COUNCIL ASSESSMENT PANEL MEETING
10 June 2020
AGENDA – 9.2

Applicant: Richard Whitehead	Landowner: M M Whitehead
Agent: Gregg Jenkins – Heynen Planning Consultants	Originating Officer: Melanie Scott
Development Application: 19/1021/473	
Application Description: Change of land use to include horse keeping (maximum 5 horses), construction of a horse keeping & farm building, outdoor arena, associated lighting & earthworks	
Subject Land: Lot:203 Sec: P3319 DP:38413 CT:5478/835	General Location: 163 Taminga Grove Bridgewater
	Attachment – Locality Plan
Development Plan Consolidated : 8 August 2019 Map AdHi/3	Zone/Policy Area: Watershed (Primary Production) Zone - Watershed Protection Policy Area
Form of Development: Merit	Site Area: 16.34ha
Public Notice Category: Category 3 Merit - Notice published in The Advertiser on 6 March 2020	Representations Received: 1 Representations to be Heard: 1

Figure 3: View Path and Mature Vegetation

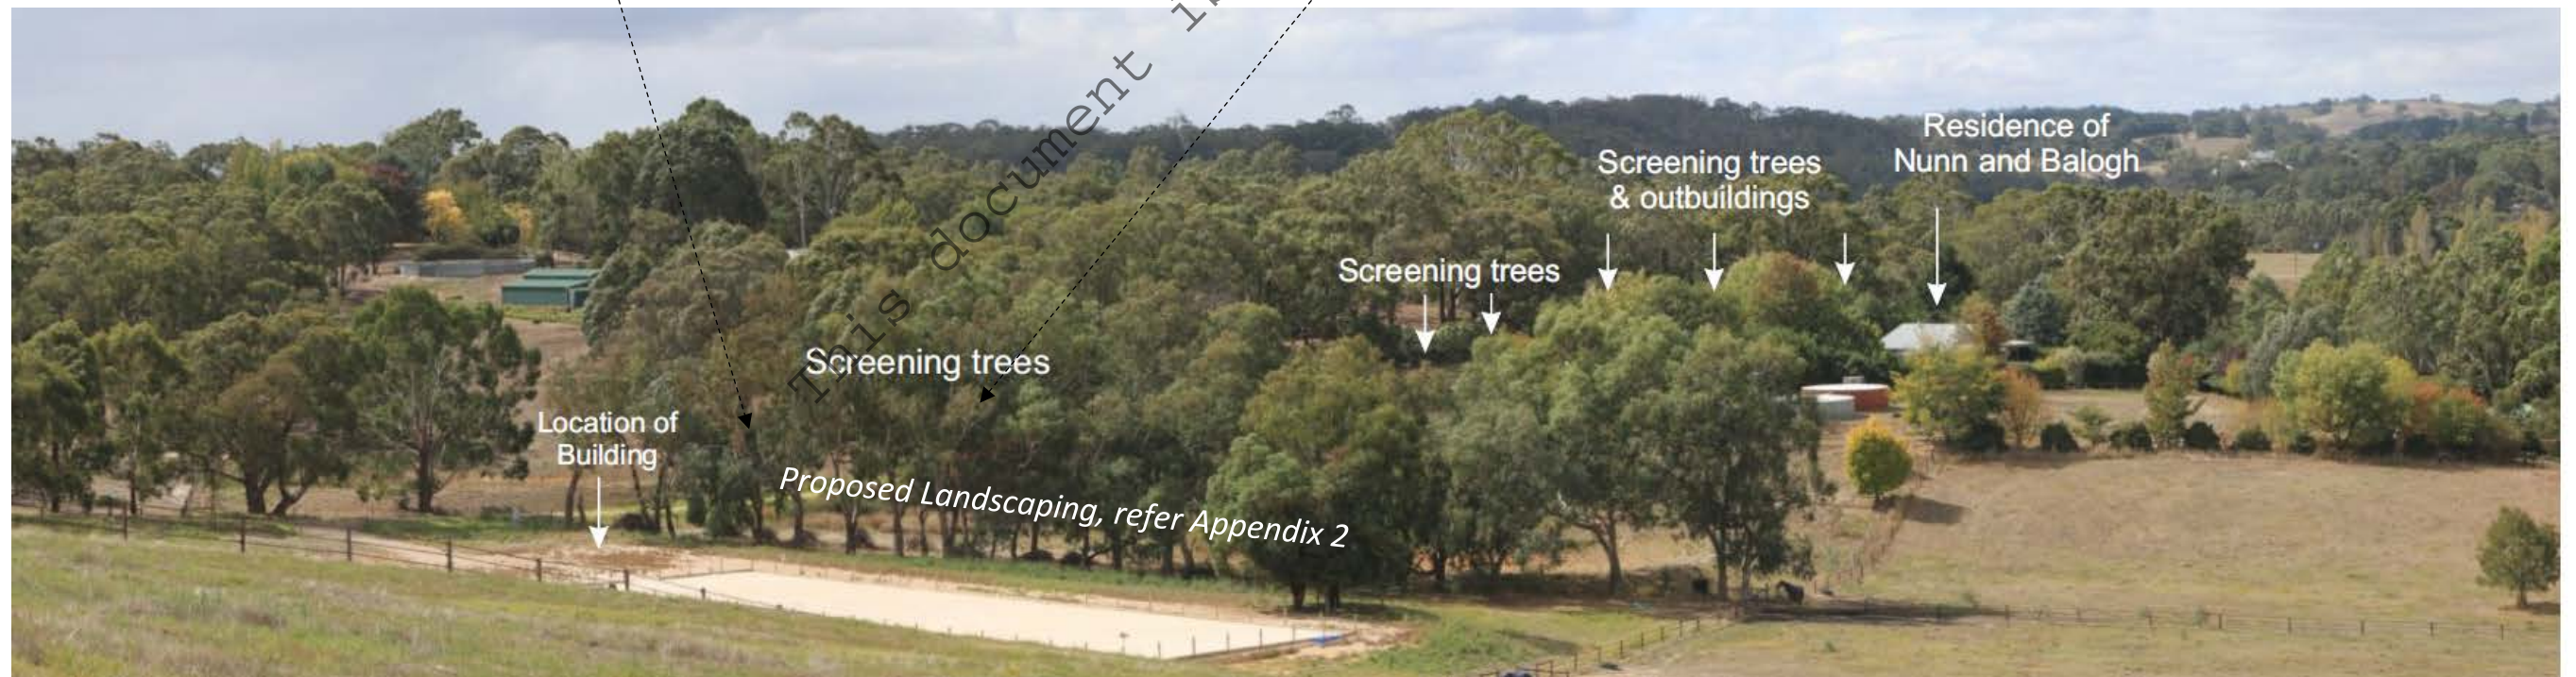
3- The line of existing gum trees between this development and our property are not a sufficient screen as they constantly drop limbs and die back. A second line of tall bushes is required. The ERD court orders part 8 state- The screen of trees and shrubs as shown on the site plan shall be retained and maintained in good health and condition at all times with any dead or diseased plants being replaced as necessary in the next planting season.REASON: To maintain & enhance the visual amenity

The ERD court orders part 9 state- Landscaping shall be planted PRIOR to occupation of the development & thereafter shall be maintained in good health & condition at all times to the Council's satisfaction. Any such vegetation shall be replaced if & when it dies or becomes seriously diseased in the next planting season.-REASON: To maintain & enhance the visual amenity of the locality in which the subject land is situated.- THIS HAS NOT BEEN DONE ! Most of the trees on our property are deciduous which makes a screen along the boundary even more important.

The “*Horse Training Field Lighting Report*” details the focused nature of the LED lighting within the arena, with the property boundary located over 28 metres from arena at the closest point (see figure 1) while figure 2 provides the location of several rows of trees that provide screening from the representors dwelling that is located 170 metres away from the horse arena.

Figure 3 provides a clear depiction of the spatial relationship between the proposed arena and representors dwelling beyond while I note that the proposed landscaping seeks to “fill in” the areas both below and adjacent the canopy of the stand of vegetation. Plants will have mature heights ranging from 2.9 metres to 9 metres, while *Eucalyptus baxteri* are proposed to each end of the vegetation (40 m at maturity).

Title		Ref No.	
Stables - Utility Building		Dwg No. 16934 - 16	
Taminga Grove - Bridgewater		Rev. 1	
Storm water and runoff management		Sheet No.	
Date.	Jan - 2020	Client.	Melissa Whitehead
		Scale. 1:20 (A3)

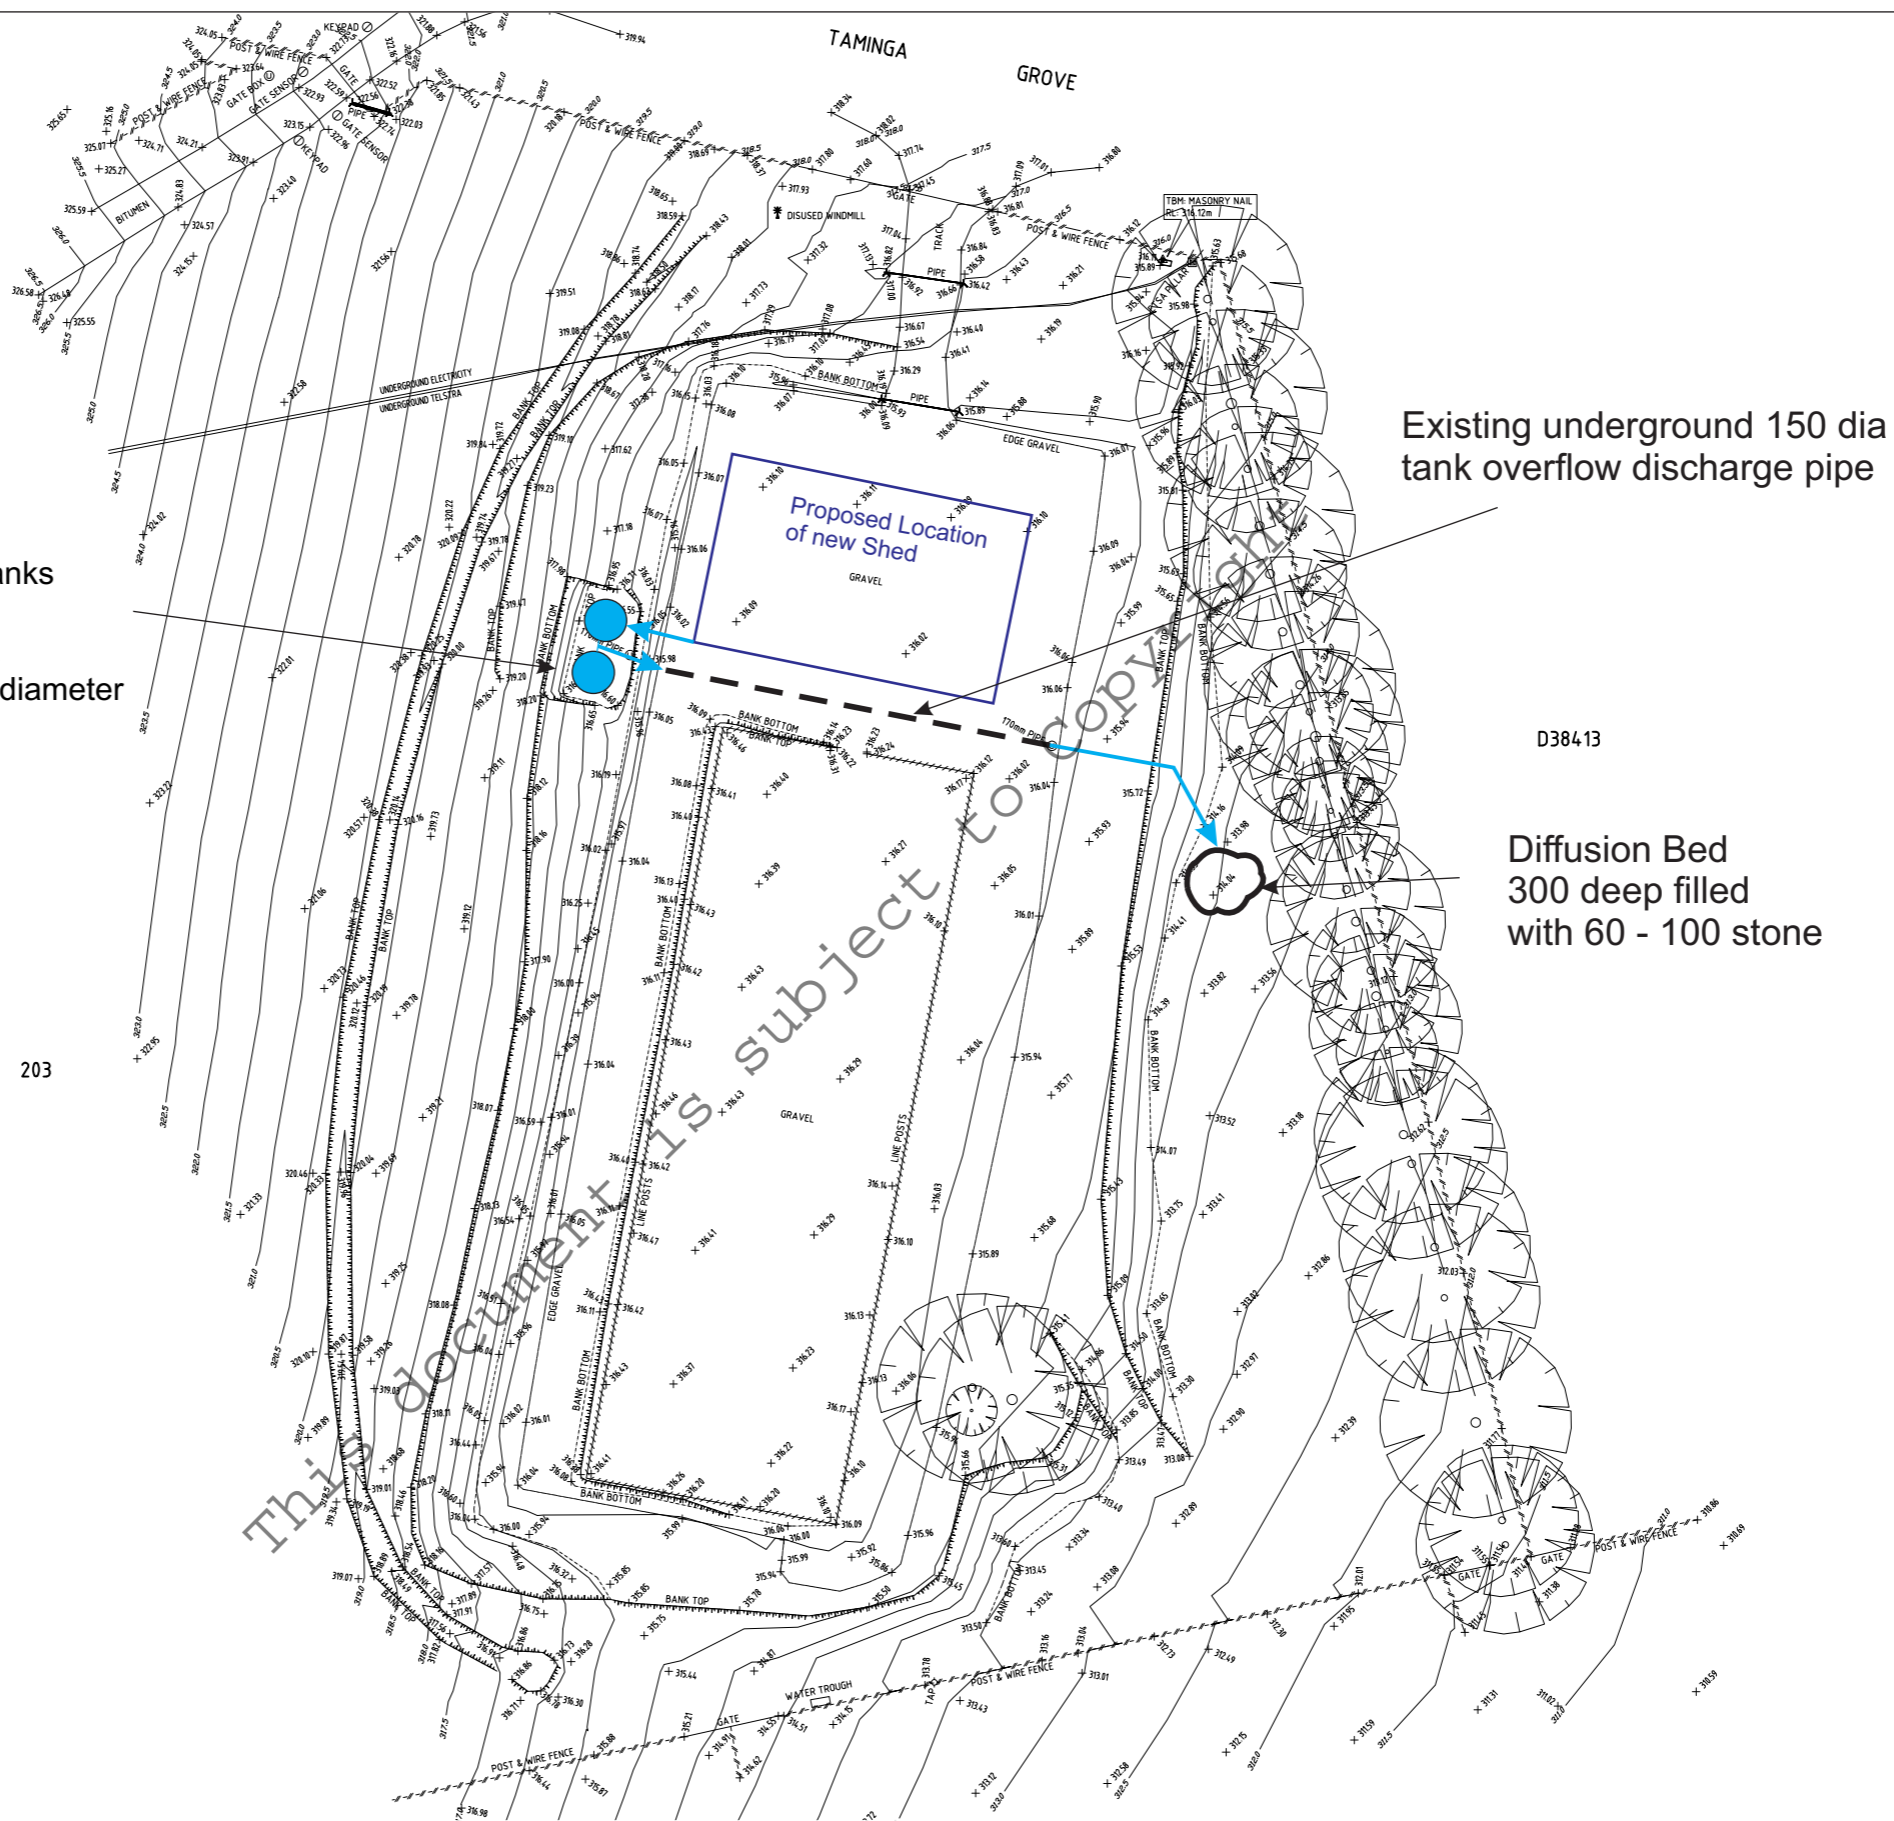
The water supplied to my horses is collected rainwater from my house and sheds. I do not intend to irrigate any pasture and will require a small amount of water for washing down horses, which I intend to utilise from the rain water collected from the proposed building. Please refer to the water management plan regarding the specifics of the water collection and water waste disposal."

Overflow from rainwater tanks shall be treated on site to the satisfaction of Council in accordance with the amended Stormwater and runoff management plan 16934 -16 rev 1 dated 5 May 2020.
